THE CLEVELAND ELECTRIC ILLUMINATING COMPANY

PY-CEI/NRR-0010 L

Perry Nuclear Power Plant
Bracket Nos. 50-440; 50-441
SER Outstanding Issue No. 9
Pool Dynamic Loads

APPENDIX 3B
CONTAINMENT LOADS

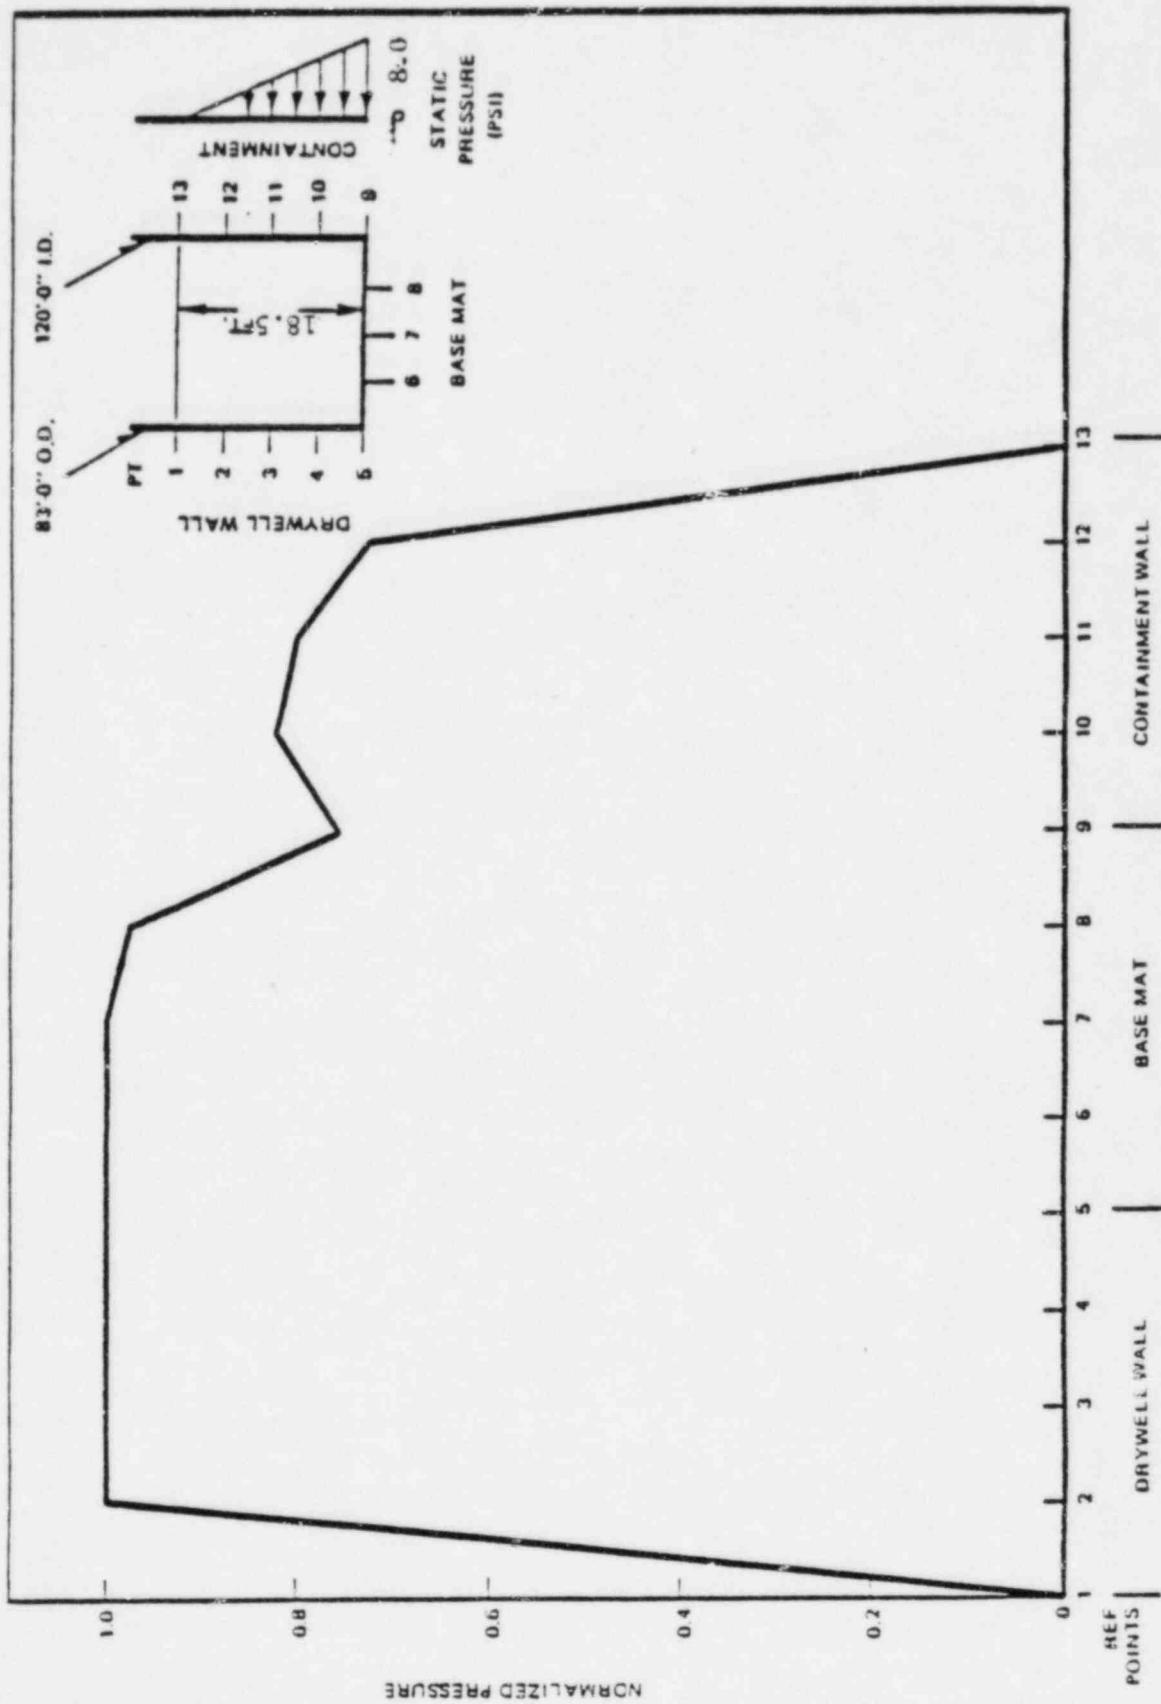
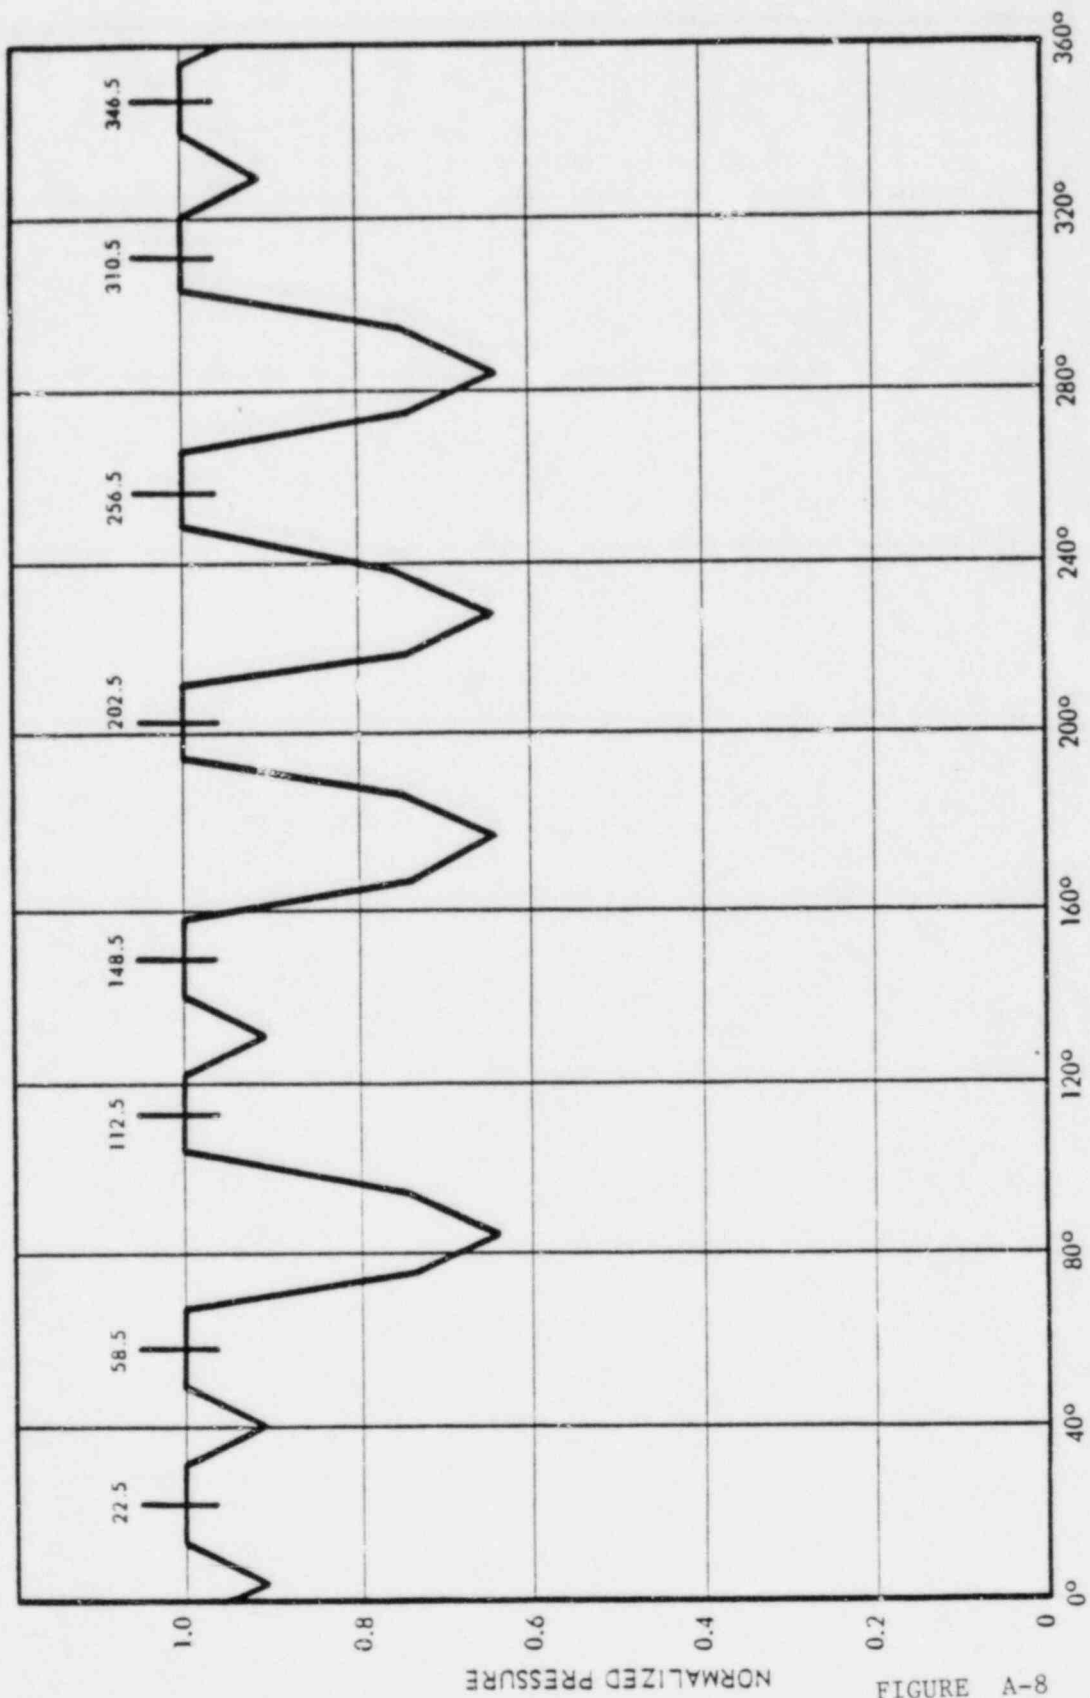
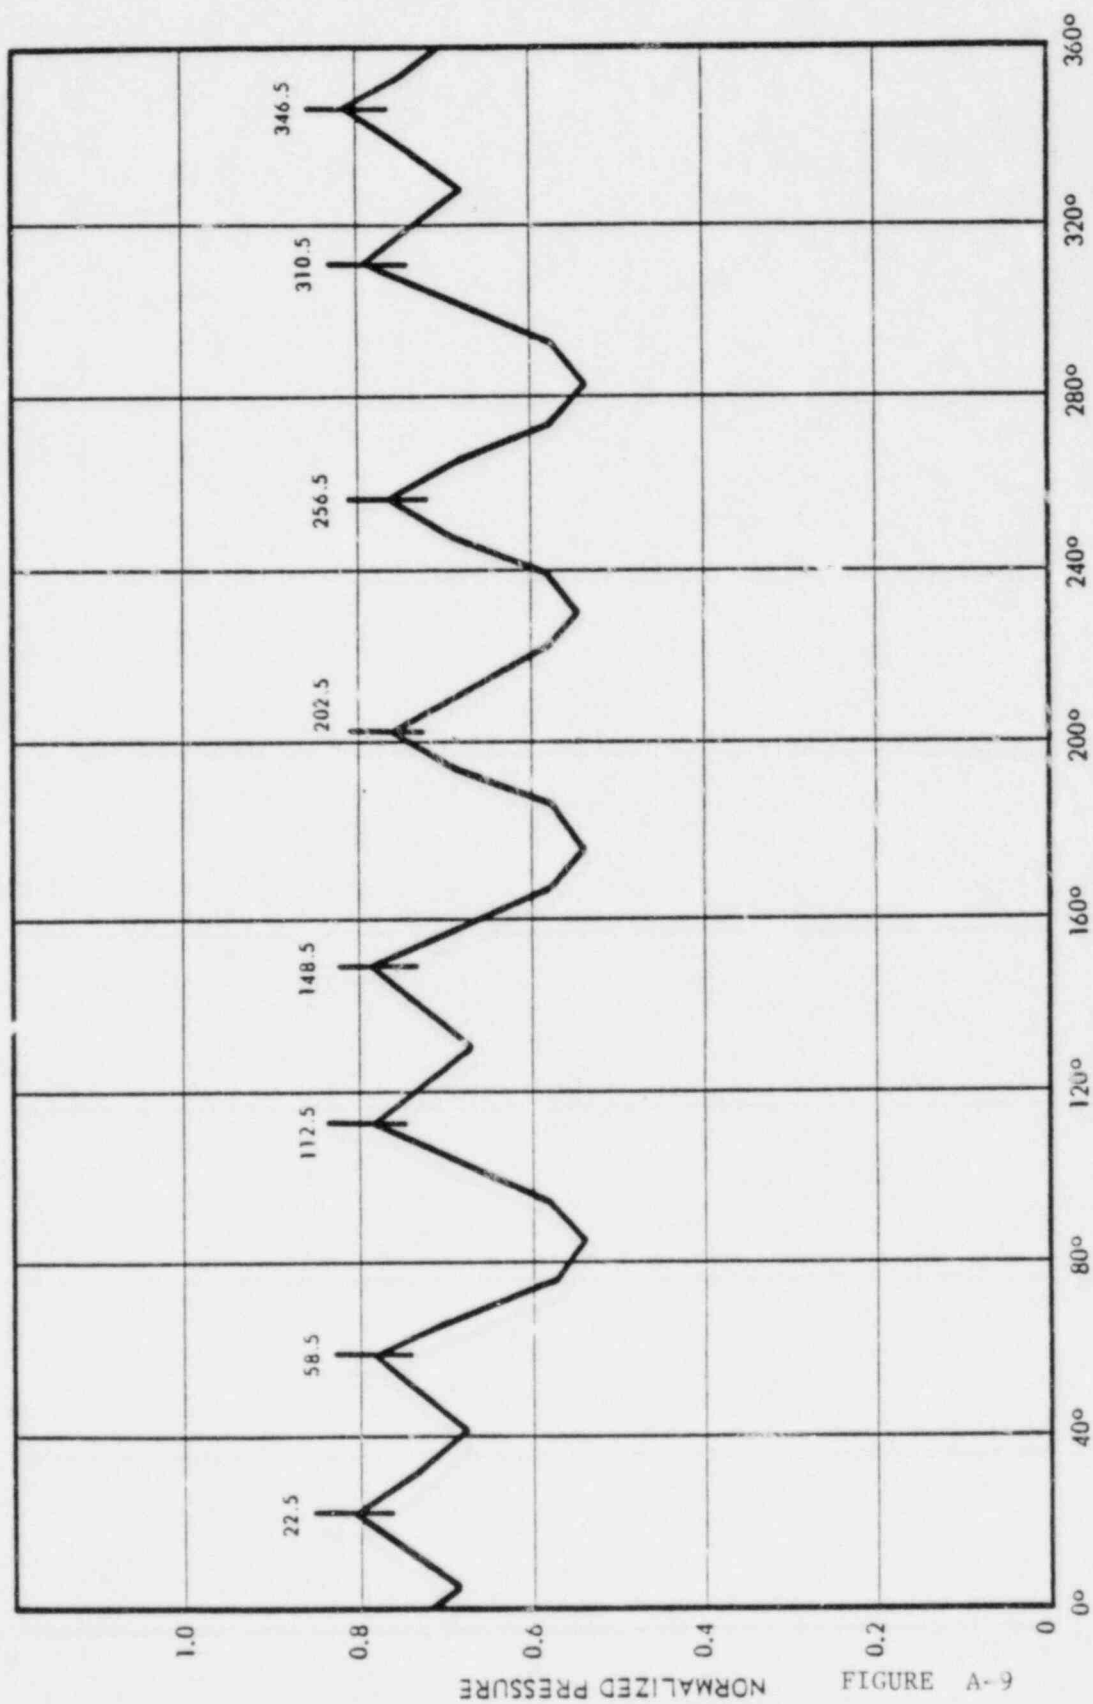
CESSAR Table 3BA-8 and Figures 3BA-14, 3BA-15, and 3BA-16 are not applicable to Perry. FSAR Table A-7 and Figures A-7, A-8, and A-9 show the normalized dynamic peak pressure field and radial and circumferential peak values for the eight ADS SRVs for Perry.

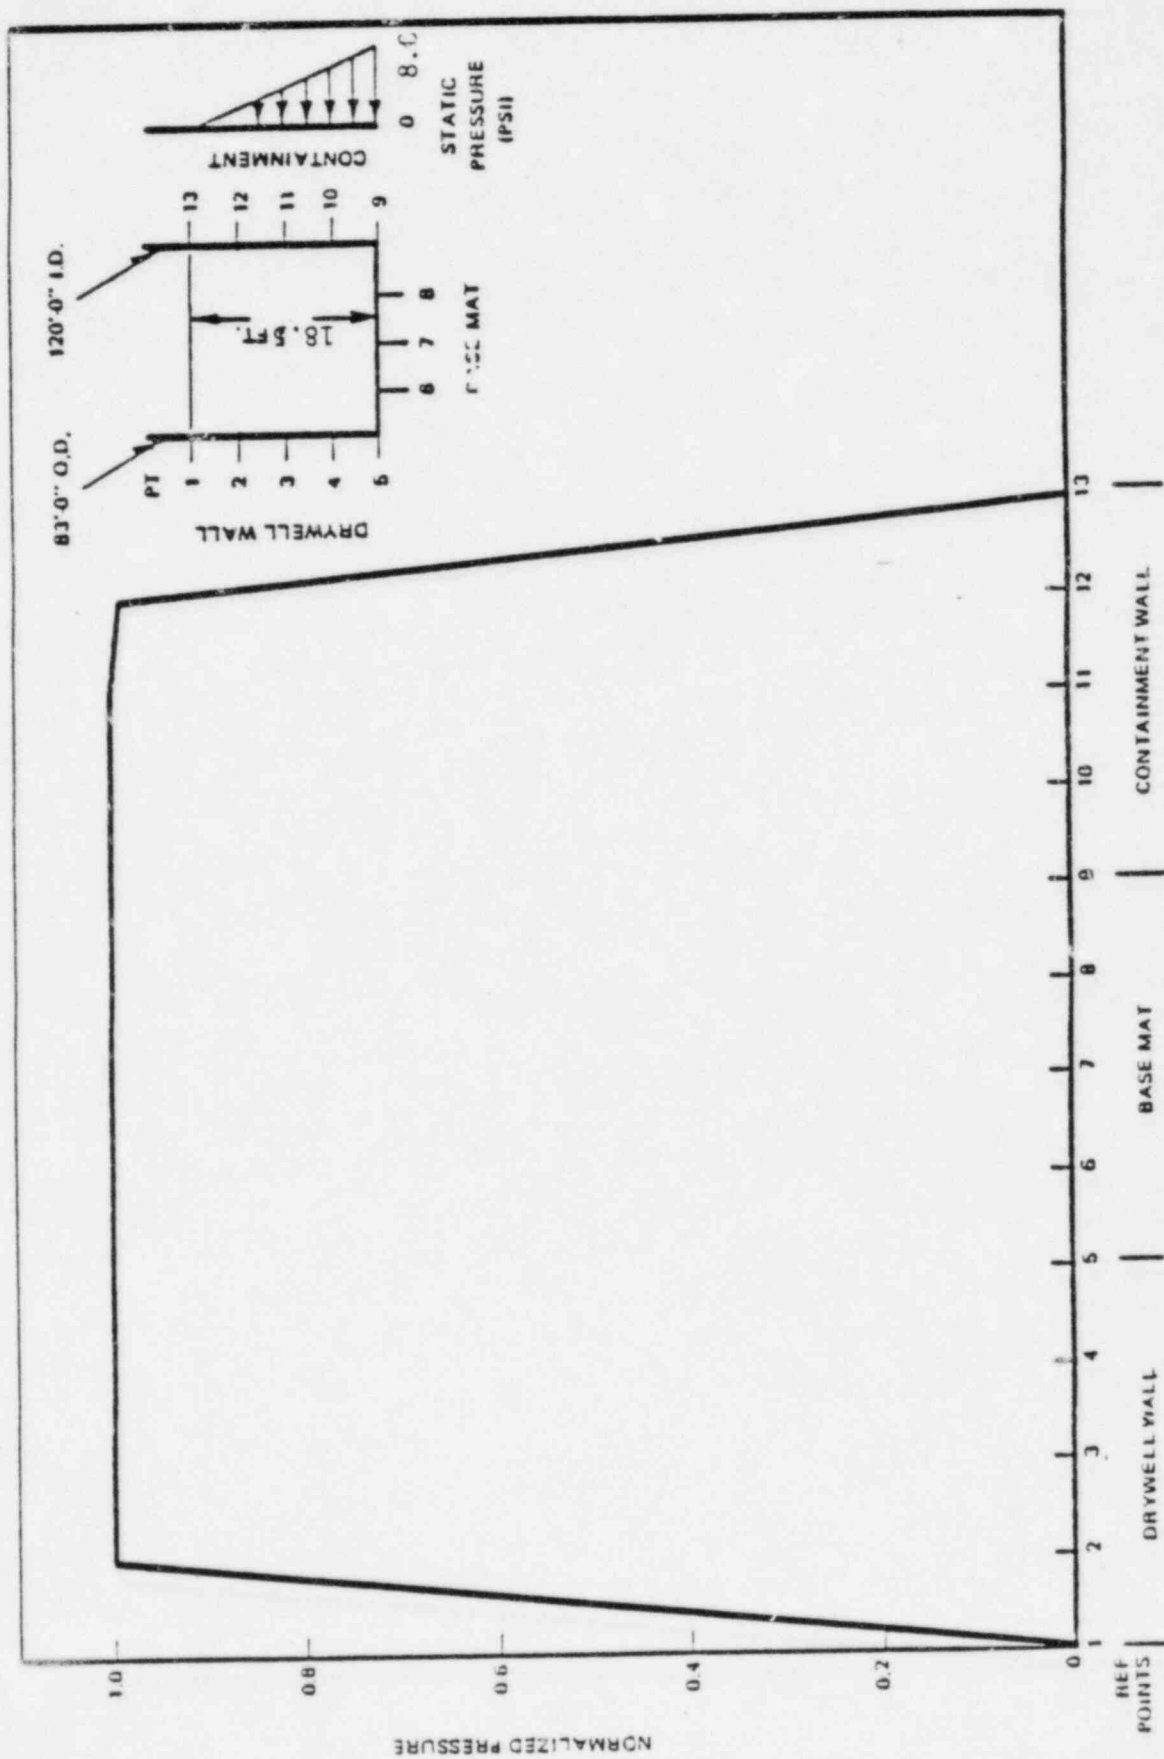
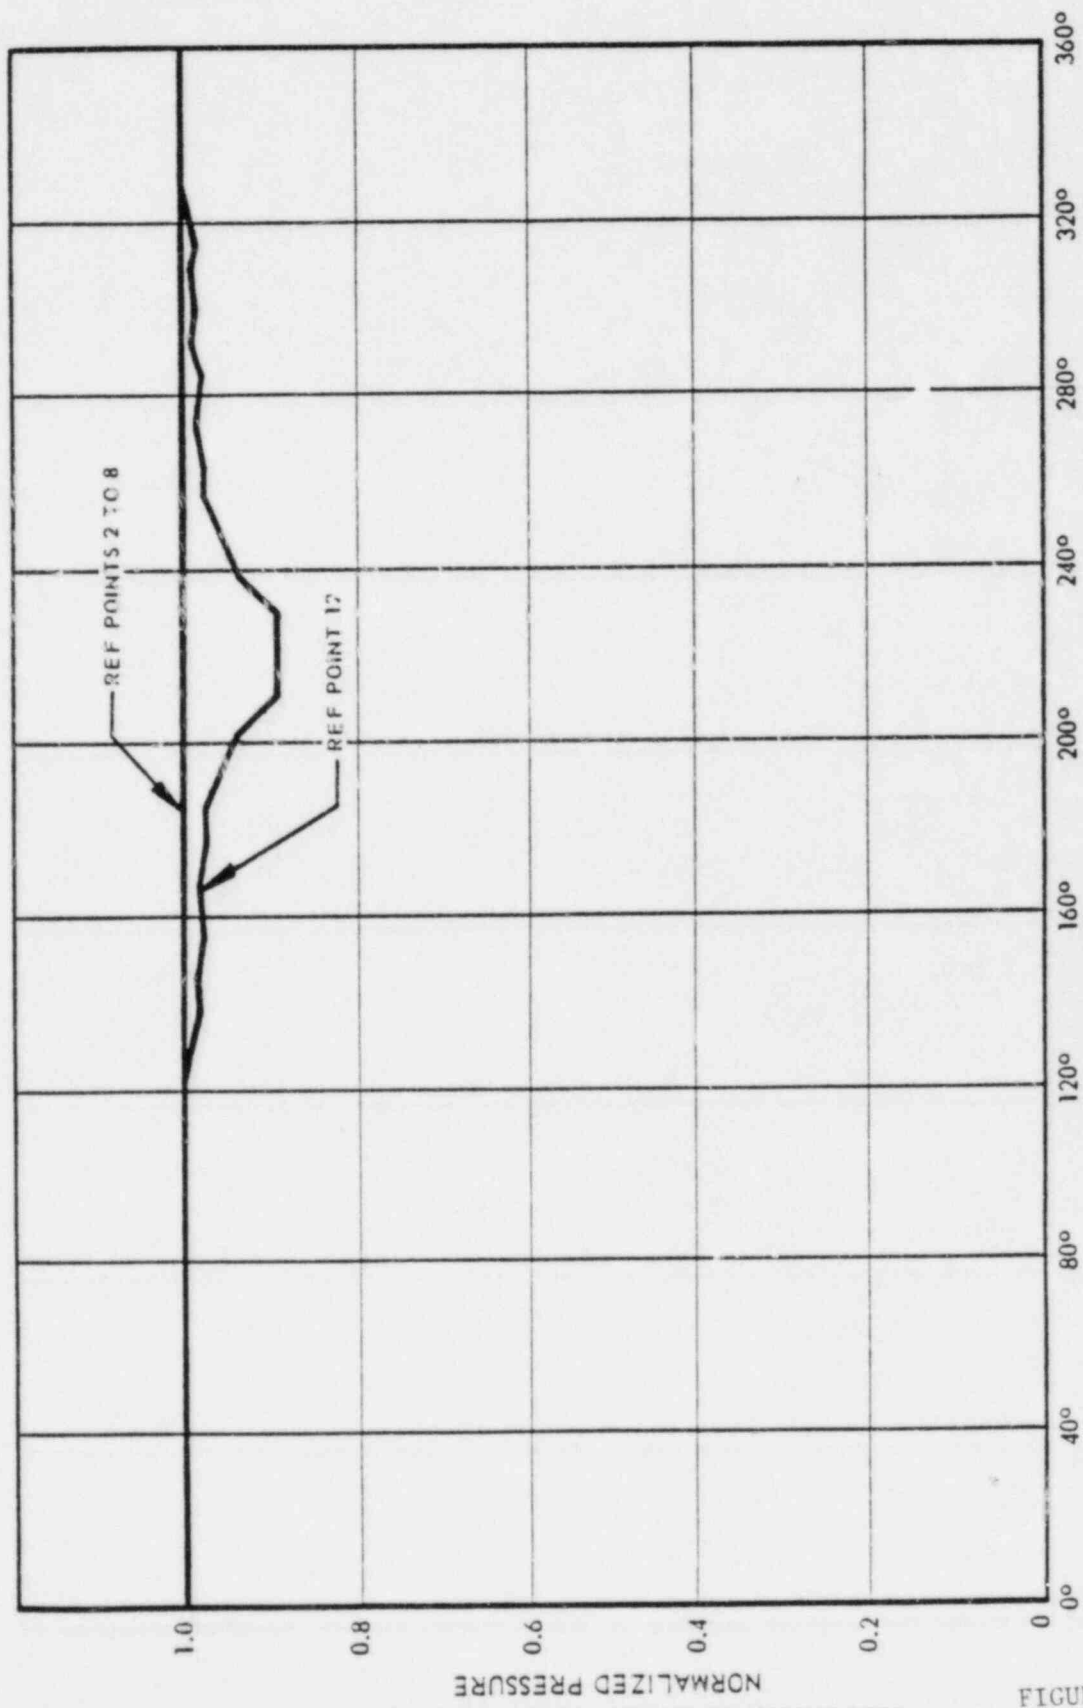
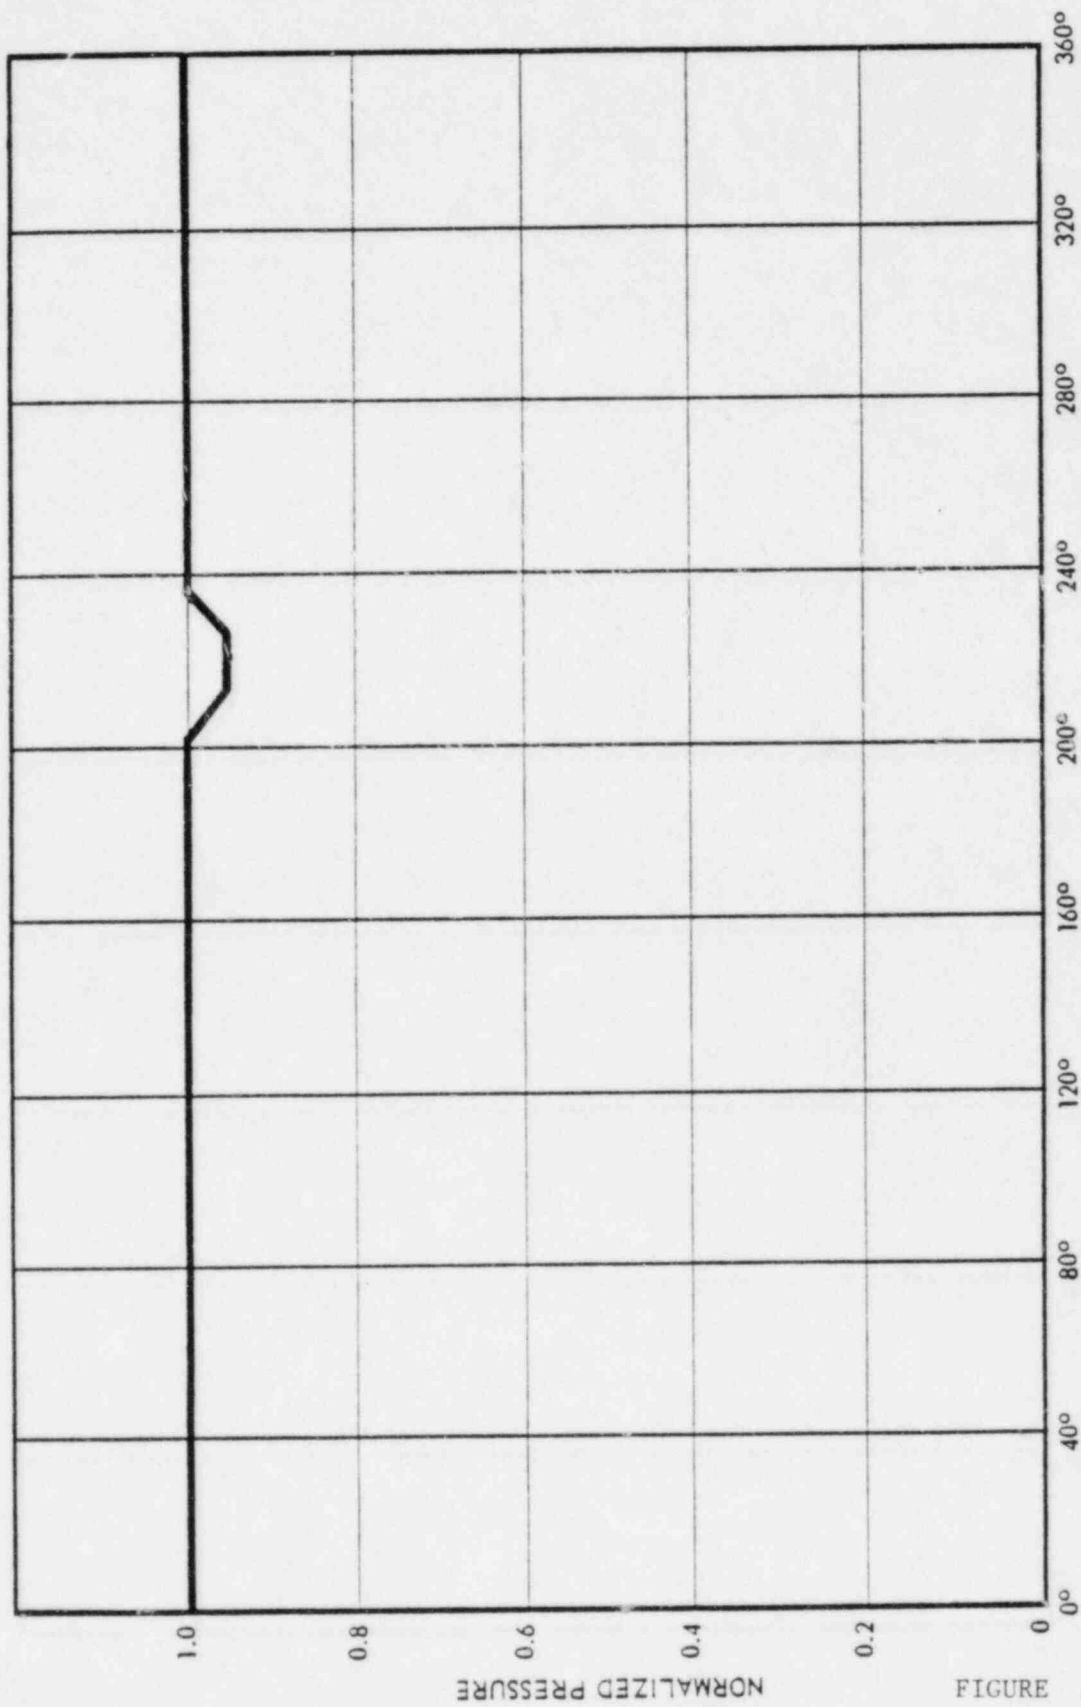
CESSAR Table 3BA-9 and Figures 3BA-17, 3BA-18, and 3BA-19 are not applicable to Perry. FSAR Table A-8 and Figures A-10, A-11, and A-12 show the normalized dynamic peak pressure field and radial and circumferential peak values for Perry.
